AMENDMENT OF SOLICITATION/MODIFICATION OF CONTRACT	1. Contract Number DCKA-2009-B-0183	Page of Pages 1 / 5

2. Amendment/Modification Number	3. Effective Date	4. Requisition/Purchase Request No.	5. Solicitation Caption
Seven (7)	See 16C		Reconstruction of Eastern Avenue Bridge over Kenilworth Avenue, NE

Attached are additional Plans that have been revised. Included:

RECONSTRUCTION OF EASTERN AVENUE BRIDGE

MAINTENANCE OF TRAFFIC PLAN
PHASE 1B

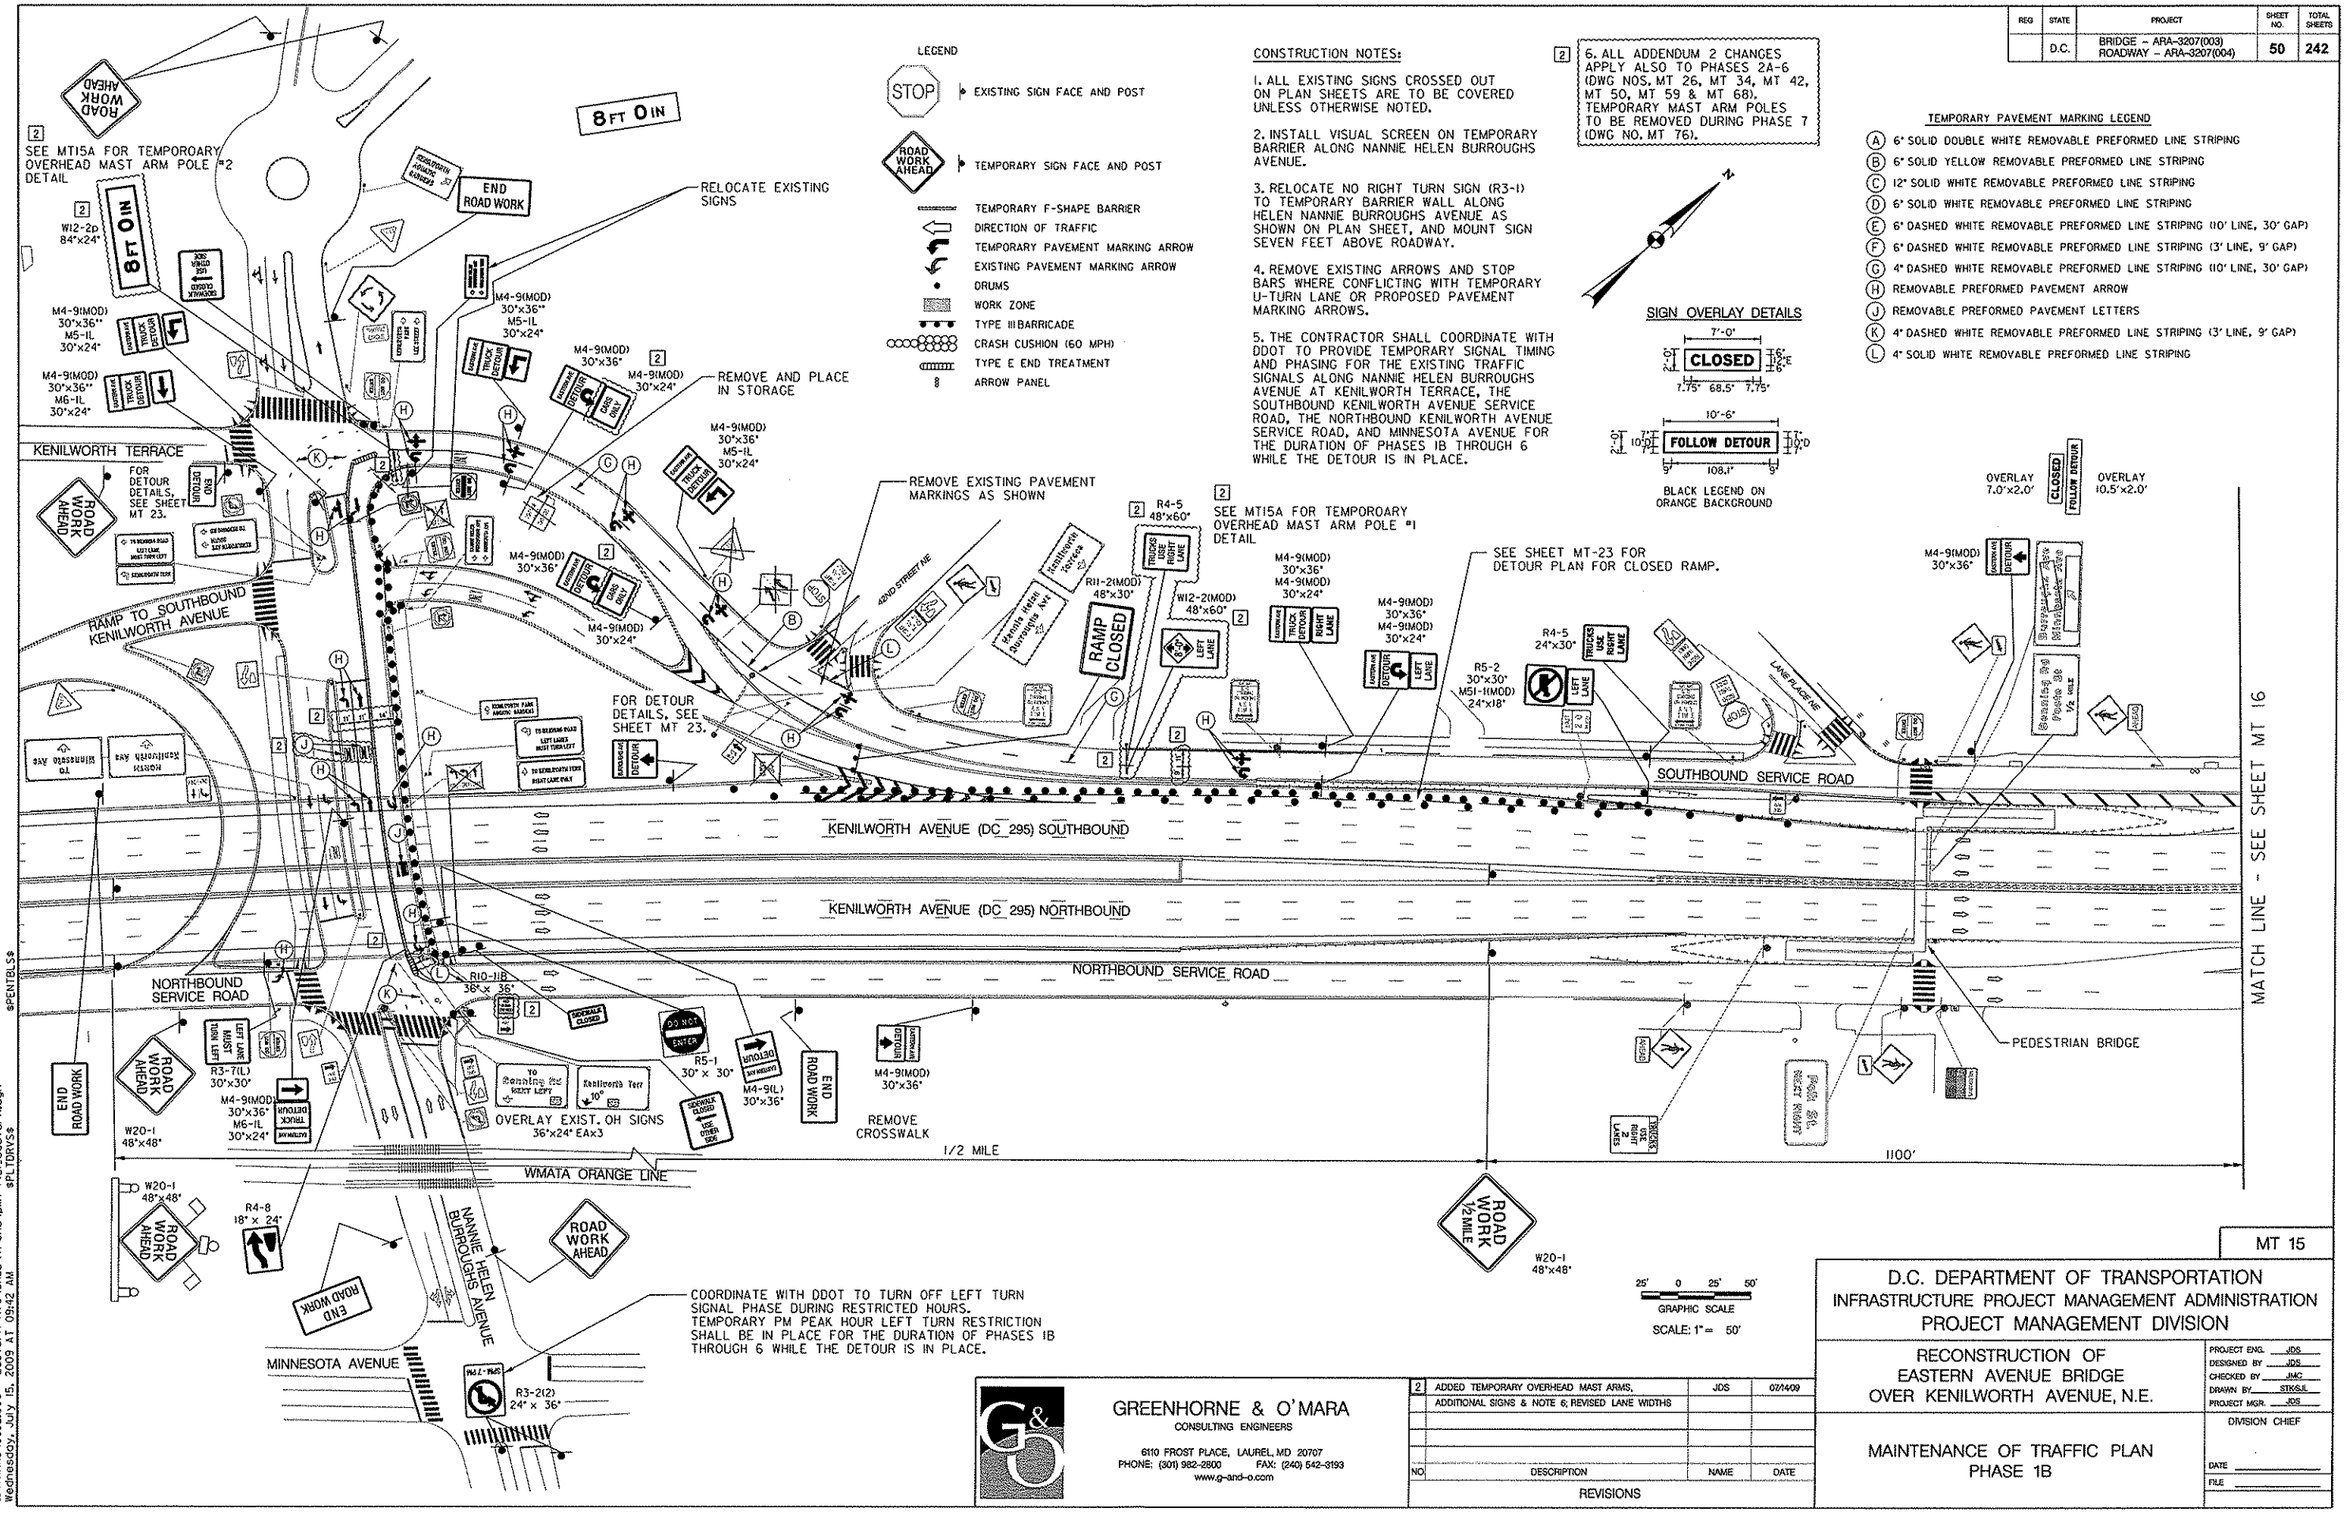
[2] 6. ALL ADDENDUM 2 CHANGES APPLY ALSO TO PHASES 2A-6 (DWG NOS. MT 26, MT 34, MT 42, MT 50, MT 59 & MT 68). TEMPORARY MAST ARM POLES TO BE REMOVED DURING PHASE 7 (DWG NO. MT 76).

NO	DESCRIPTION	NAME	DATE
2	ADDED TEMPORARY OVERHEAD MAST ARMS, ADDITIONAL SIGNS & NOTE 6; REVISED LANE WIDTHS	JDS	07/14/09
